SECTION 00 91 13.1 – ADDENDUM 1

- A. Project Name: LiUNA Local 120.
- B. Owner: LiUNA Local 120 – Ward Daniels Business Manager.
- C. Architect: arcDESIGN, PC.
- D. Architect Project Number: 21102.
- E. Date of Addendum: January 7, 2022.

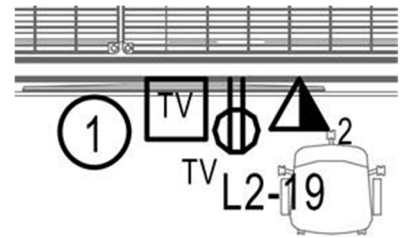
- B. Question: Please clarify the low-voltage rough-in requirements for the TVs. The screenshot below is a typical TV arrangement in the office areas. Is the design intent for there to be (3) LV stubups serving this area: (2) 1" Stub-Ups per Detail 5/E902 and (1) 1-1/4" Stub Up per Detail 7/E902.

1. Answer: Detail 7 conduit size should be 1" not 1-1/4". I think the only location this detail applies is at the Hall A/V rack location. There should only be (2) 1"C per Detail 5.
